MINOR PROJECT REFINEMENT REQUEST FORM

Request Number: 05- Revision 01

Client/Project 185705825
 PG&E Humboldt Bay-Humboldt #1 60kV
 Minor Project Refinement 05

Minor Project Refinement Request #5
Humboldt Bay- Humboldt #1 60kV Reconductoring Project
9/29/22 (Revision 1)

Pole 66 Relocation and Overland Travel

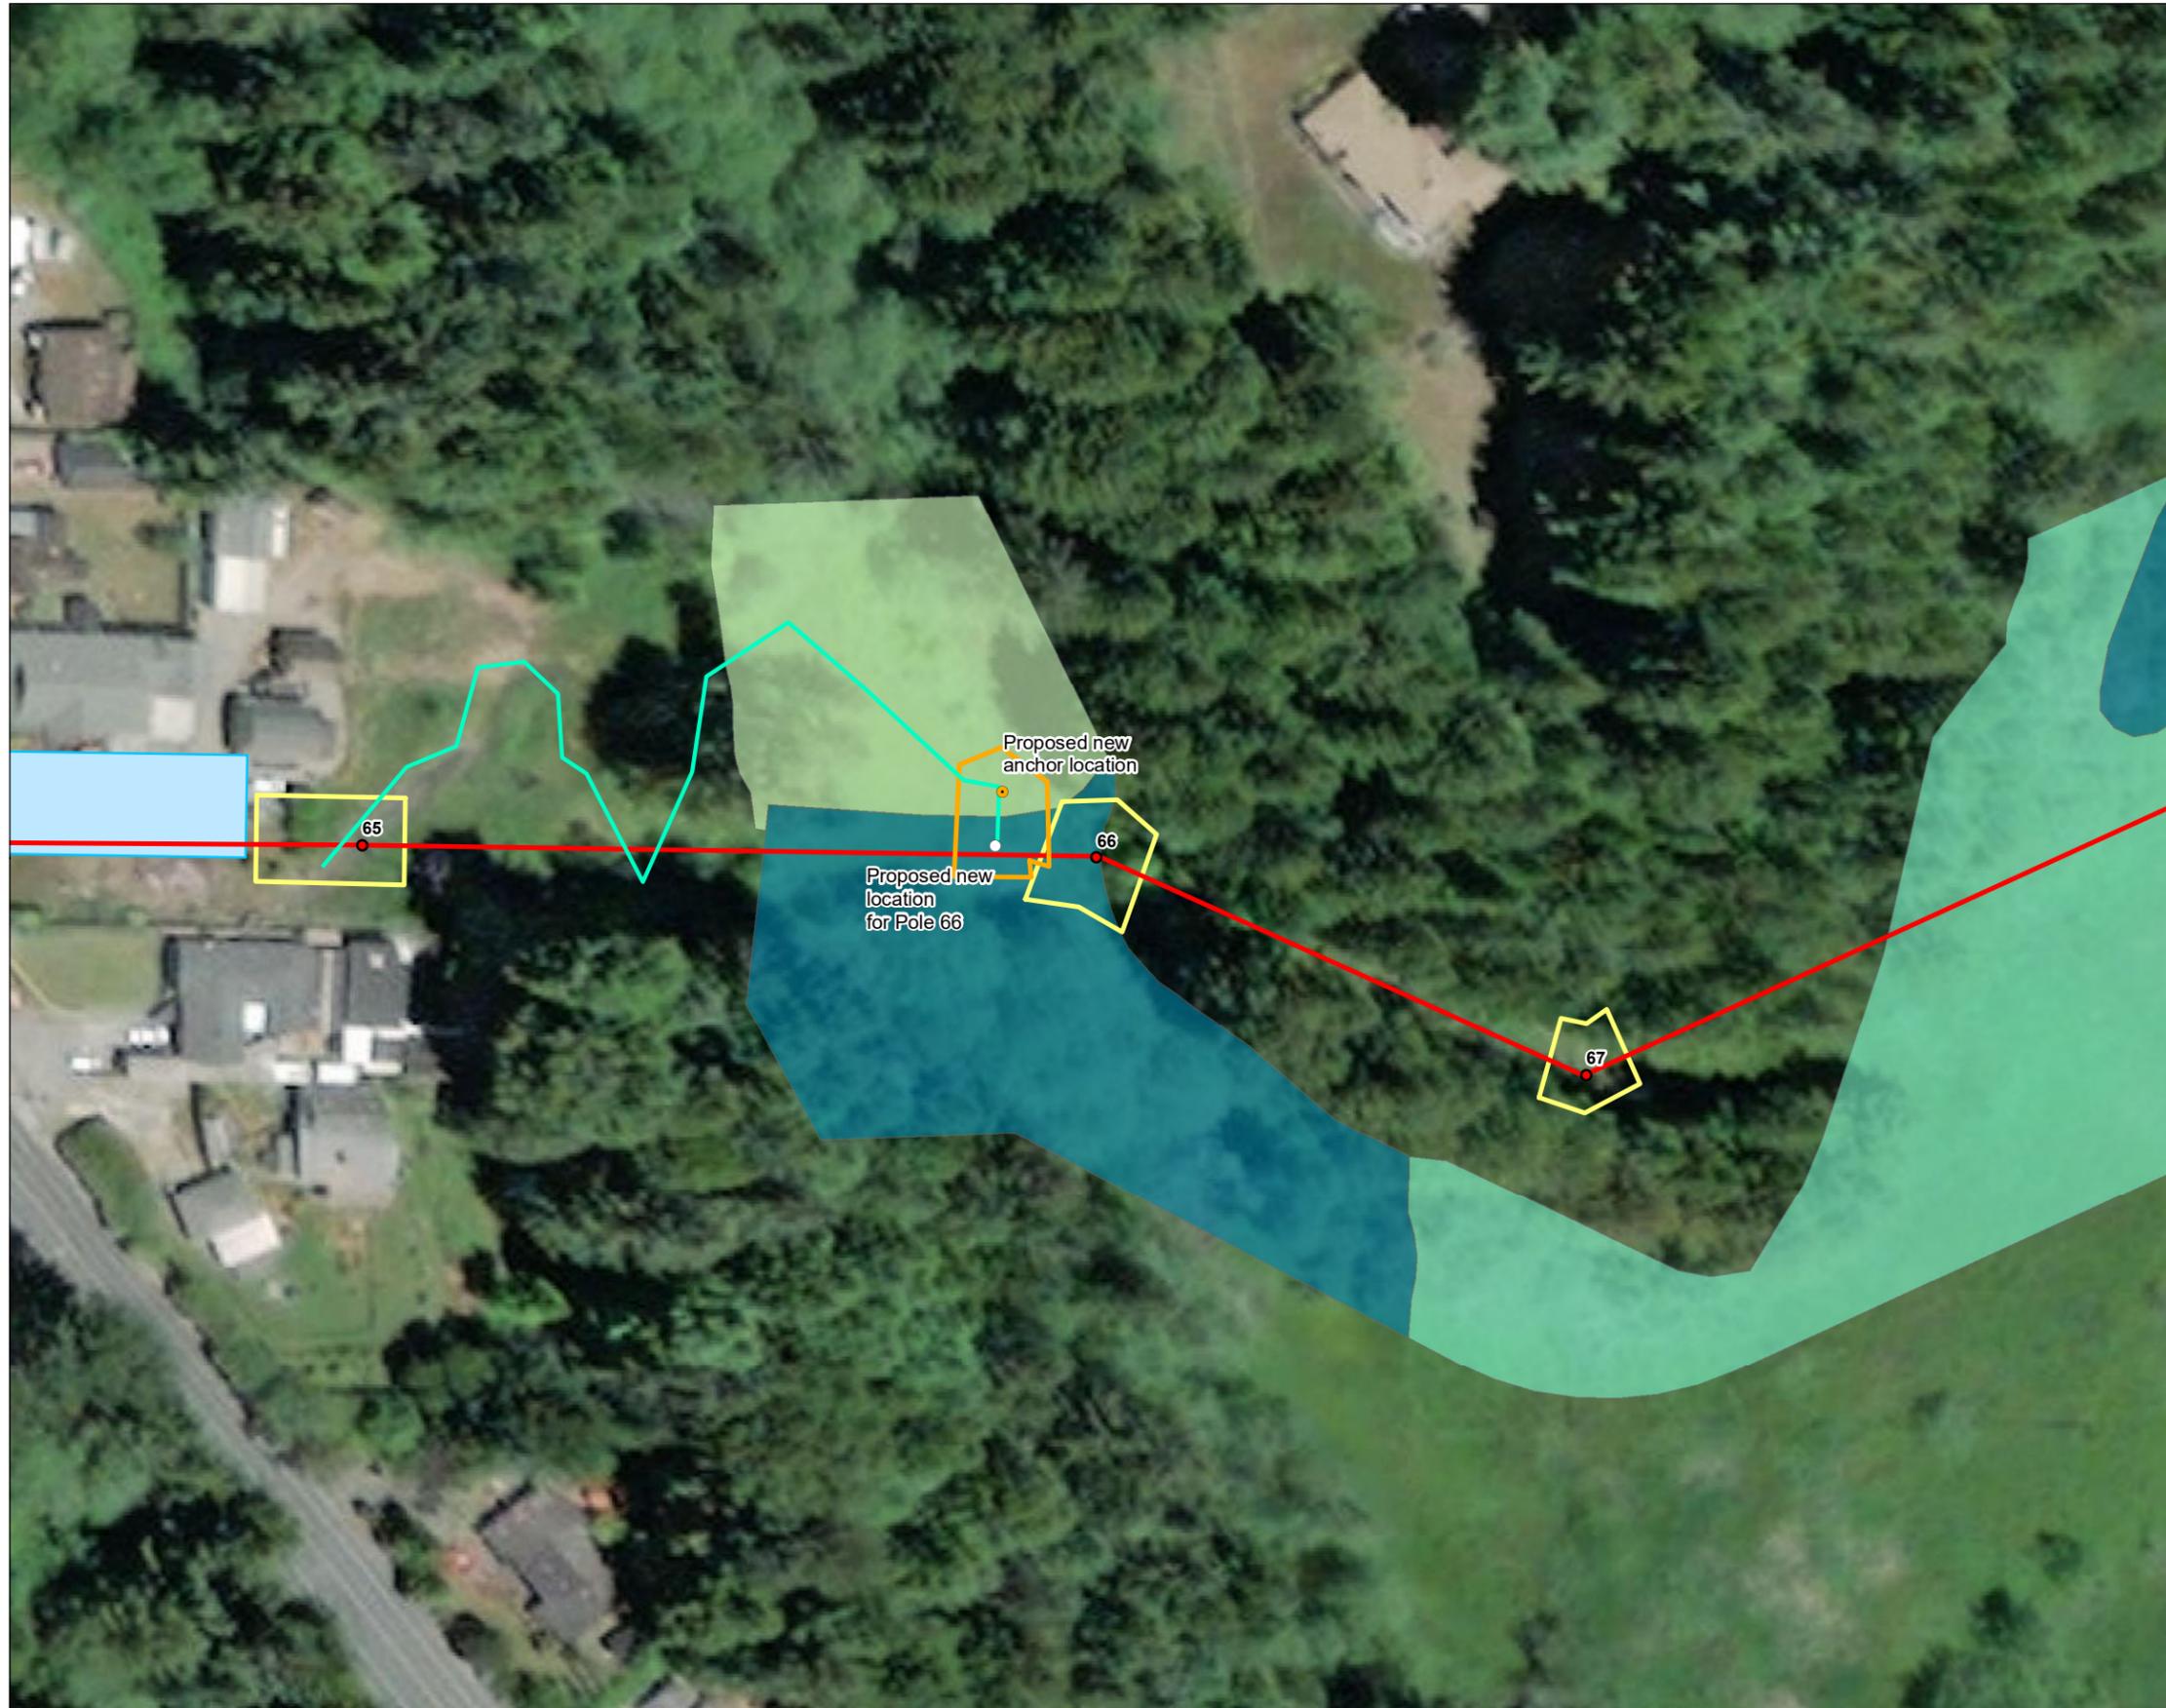
PG&E proposes to move Pole 66 (an angle pole) and its associated anchor approximately 40 feet west towards Pole 65 to relocate the pole outside of a saturated wetland. The pole is located on a residential parcel in the City of Eureka (APN: 018-211-005-000). PG&E proposes to access the new pole location via a new overland access route, some of which has been established by the landowner. The proposed new pole location and access route are located within the study area of the Final IS/MND.

Engineering has identified a preferable location for the replacement pole approximately 40 feet west of the existing pole towards Pole 65. The proposed pole site is within a dry portion of the wetland. Moving the pole will reduce construction-related impacts on saturated wetlands and will facilitate less impactful access for pole maintenance.

The new overland access route would cross approximately 150 feet of dry emergent wetland (see Figure 1). The route would be used by a tracked excavator that is needed for new pole excavation and culvert sleeve installation. Temporary impacts to wetlands from use of the new overland route would be minor given the limited use of the route. In accordance with APM-09, the access route would be matted within wetlands if work occurs during wet conditions. Consistent with the IS/MND, temporary impacts to wetlands from the pole relocation and overland access route would not involve grading but involve minor surface disturbance from driving and staging equipment.

Replace pole 66 approx.
40' west, towards pole 65.

12' offset from existing
pole 66 to replacement
conductor
